NUREG-0139

environmental statement

CLINCH RIVER BREEDER REACTOR PLANT

U. S. Nuclear Regulatory Commission • Office of Nuclear Reactor Regulation

FIGURE 2.7 Archaeological and Historical Sites

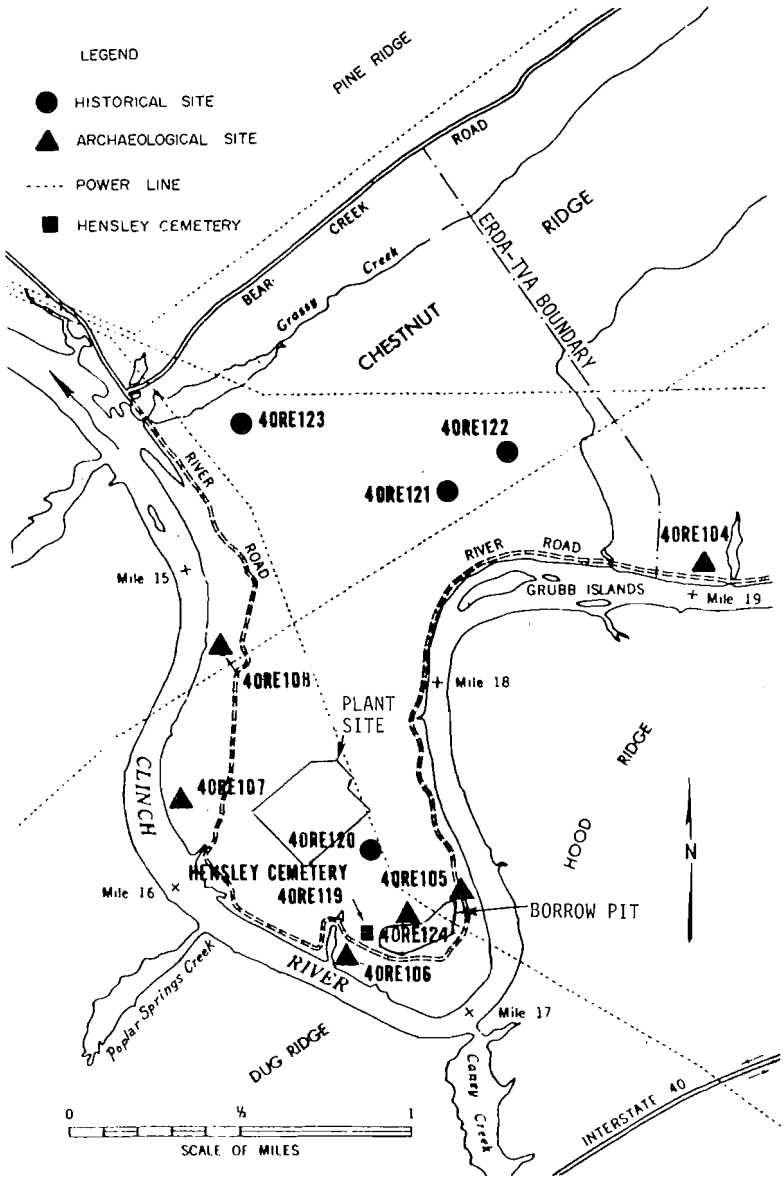
figure 2.7 should indicate construction areas.

The Advisory Council on Historic Preservation states that historic and archaeological values receive adequate consideration in the DES (page A-2). The staff considers the discussion in Section 2.3 adequate in view of the anticipated impacts, which are judged to be small (Sections 4.2.1 and 5.1). Construction areas have been added to Figure 2.7. Refer also to Figures 2.3 and 3.3.

FIGURE 2.9 Annual Onsite Wind Roses (ER, Fig 2.6-4 and -9)

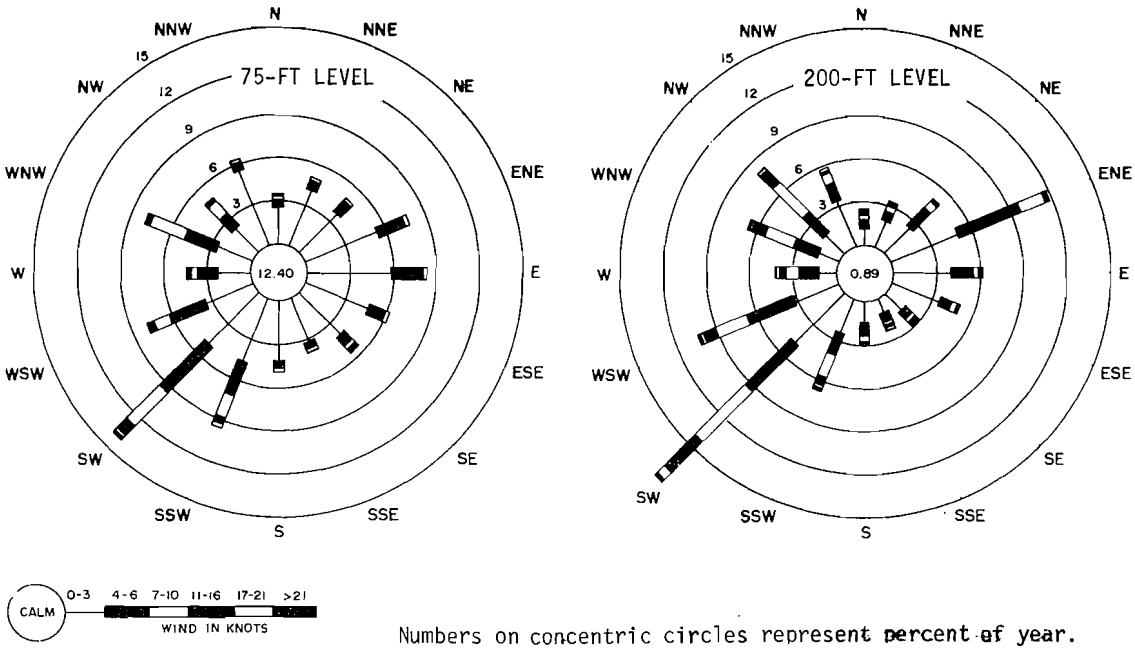
13. Figure 2.9 should be labeled such that it is apparent whether the wind roses indicate the direction from which the wind is blowing or to which the wind blows.

FIGURE 3.8 Intake Pipe

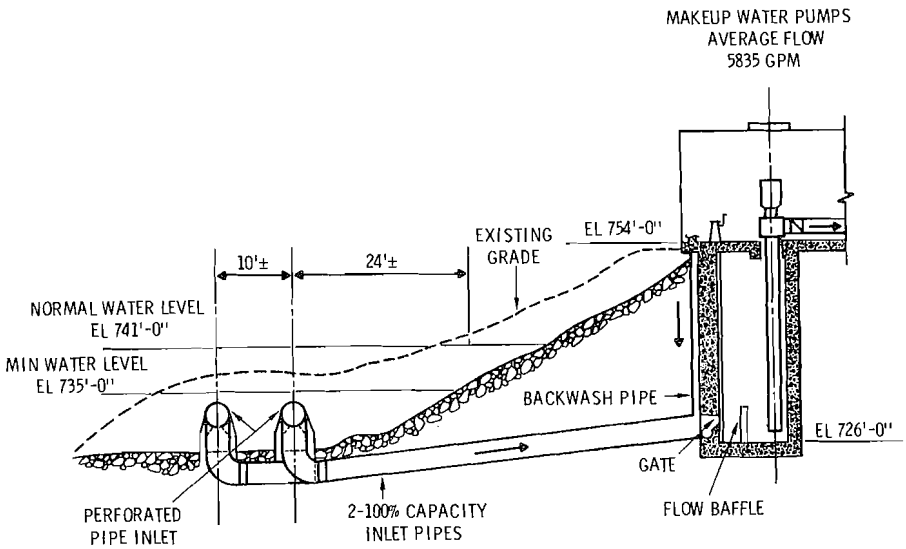
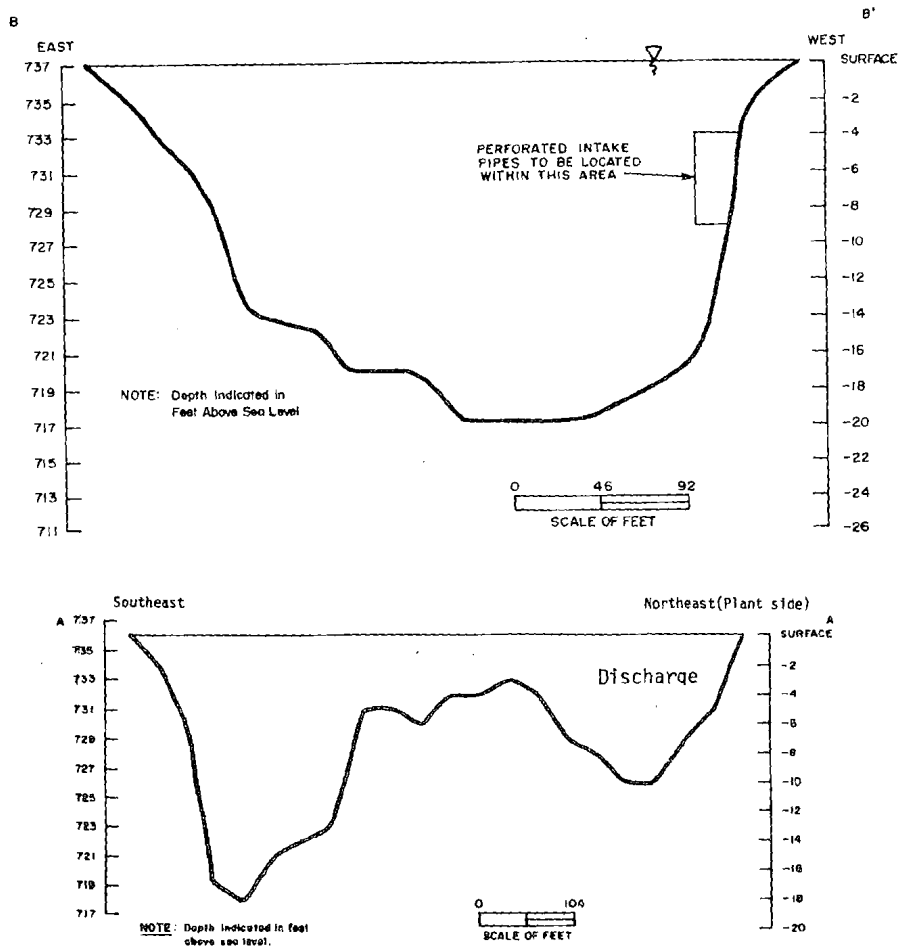
Figure 3.8 shows the tops of two intake pipes at approximately elevation 733 msl or higher. Figure 3.14 shows "intake pipes to be located within this area," the top of which is 724 msl. These figures should be checked for errors or discrepancies.

Figures 3.8, 3.12 and 3.14 have been revised in accordance with the Project's revised application to the Corps of Engineers (Caffey; July 8, 1976). Both the intake and dis· structures are recessed into the river bank to avoid obstructing navigation.

FIGURE 3.16 Gaseous Radioactive Waste Systems and CRBRP Ventilation

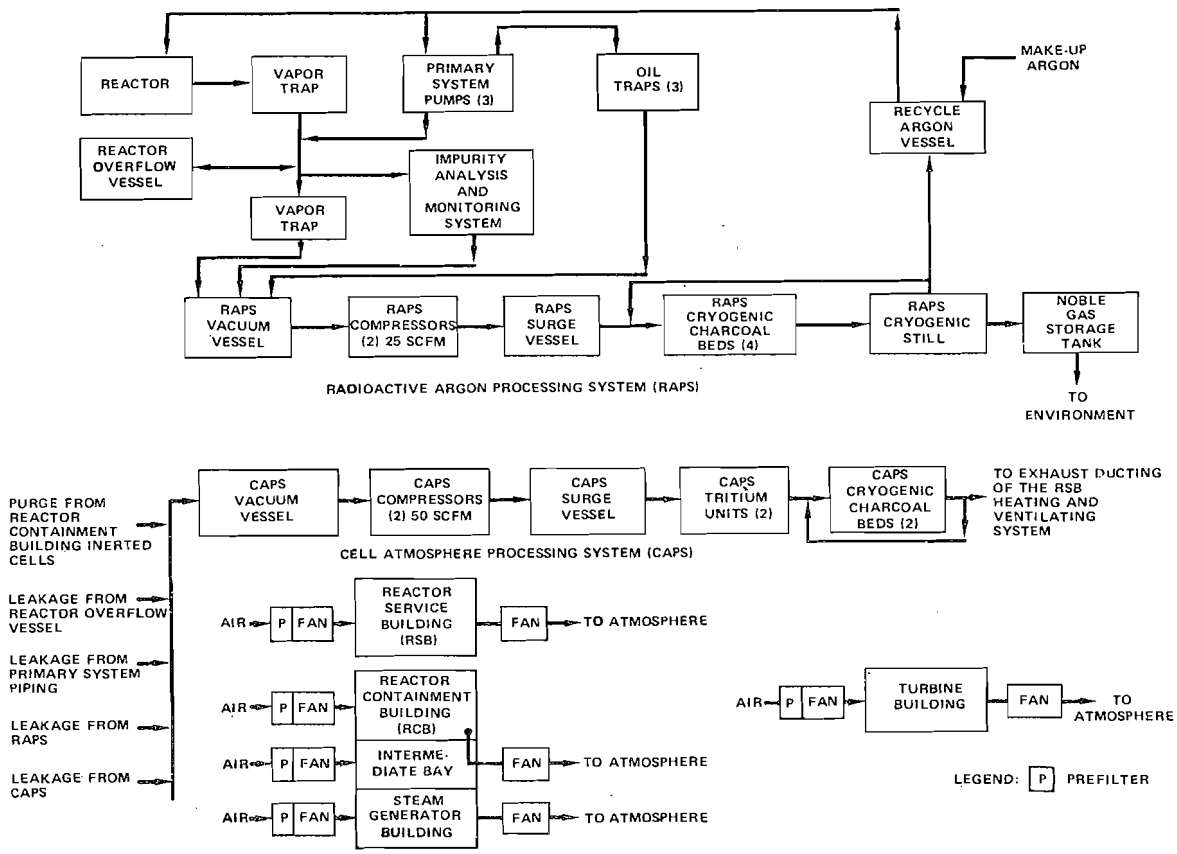
The schematic of the radioactive gase processing system in WASH-1509 (p.50), unlike the schematic in Figure 3.16 in the DRAFT (p.3-15), does not show a flow path from the noble gas storage tank to the environment.

FIGURE 5.2 Thermal Plumes, Winter Typical
(ER, Am I, Part II, D8, p A1-197)

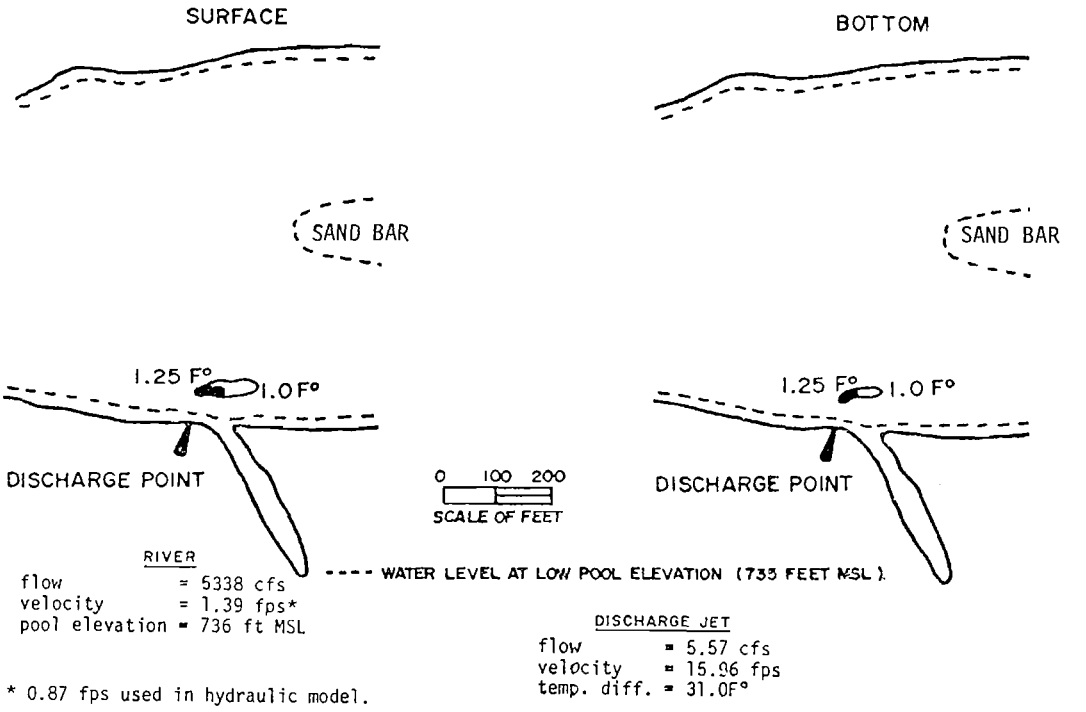
5. On page 5-8 line 6, Figure 5.2 should read Figure 5.4.

FIGURE 6.2 Reservoir Monitoring Network for CRBRP (ER, Fig. 6.2-2)

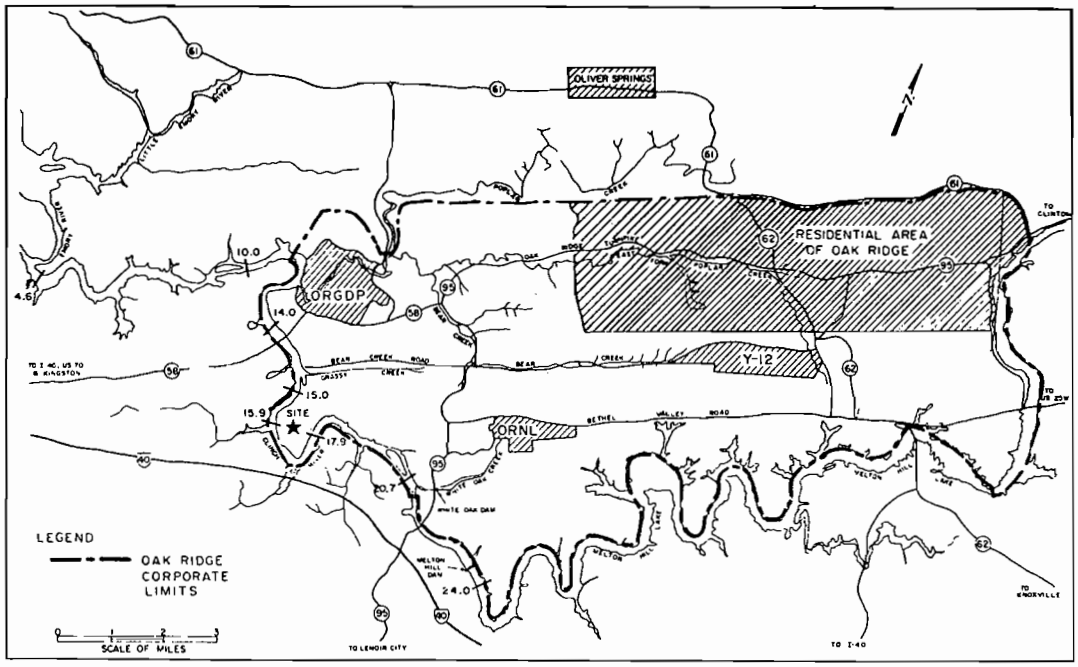
The pre-operational monitoring program at reservoir locations does not list these locations and the accompanying Figure 6.2 has no legend (pages 6-2, 6-3). In the later design of the operational radiological monitoring program (page 6-11), consideration should also be given to monitoring of storm drainage from buildings and yards, among other items.

to 10 miles, the approximate distance to the Route 62-Oak Ridge Turnpike intersection. According to information provided by the Oak Ridge Planning Office, the 10-mile distance between the plant and Oak Ridge places more than half the city's residences beyond the 10-mile radius and shows the nearest residence at 7 miles. Disproportionately large growth to the southwest, of course, could reduce the distance from the plant to residents of the city. However, the staff is not aware of forecasted growth weighted significantly to the southwest. Figures 2.1, 2.2, and 6.2 have been revised.

The political jurisdiction of Oak Ridge is shown on Figure 6.2 as revised. Showing the boundaries of the service districts cited in the Oak Ridge comment is not essential to this statement. However, the staff's assessment of costs of municipal services resulting from the project is intended to include additional costs to the service jurisdictions.

Revised Table 6.1, along with Figures 6.1 and 6.2, should adequately identify the rese tions where samples will be taken. Consideration will be given to monitoring storm dr buildings and yards in design of the operational monitoring program.

Figure 1

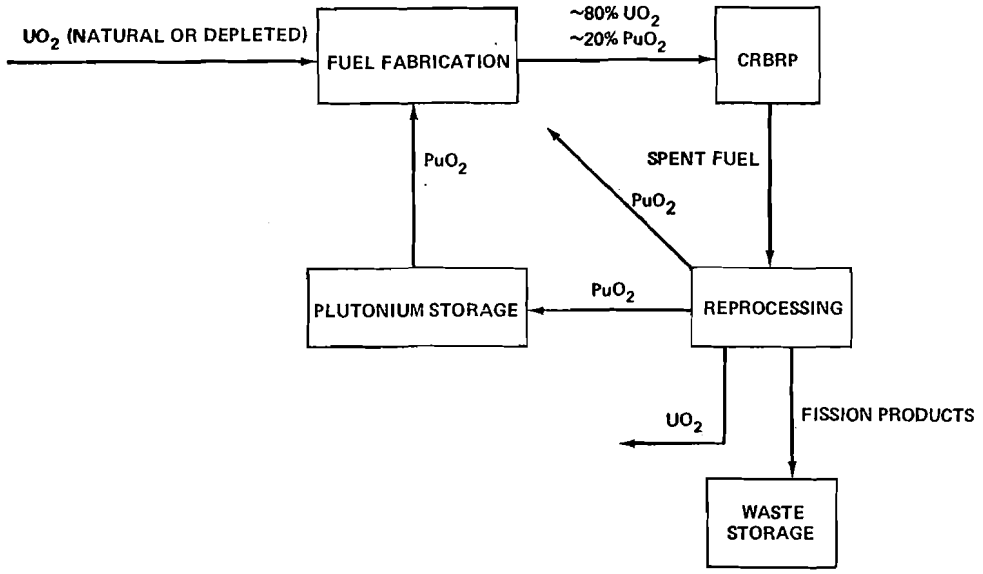
1. The text of Appendix D makes the point that depleted uranium, a byproduct of past enrichment processes carried out in this country, will be used as blanket and make-up fuel material for the CRBRP core. However, Figure 1 of Appendix D, and Section 5.1 of Appendix E, indicate that natural uranium could be used in place of or in addition to depleted uranium. In our view, the reduction of uranium mining and milling impacts by utilizing existing stocks of depleted uranium, is an important benefit of the LMFBR. Such use also is in direct accord with NEPA's mandate to achieve the, "...maximum attainable recycling of depletable resources." We hope the use of natural uranium, as opposed to depleted uranium stocks, will be minimized in the CRBRP fuel cycle.
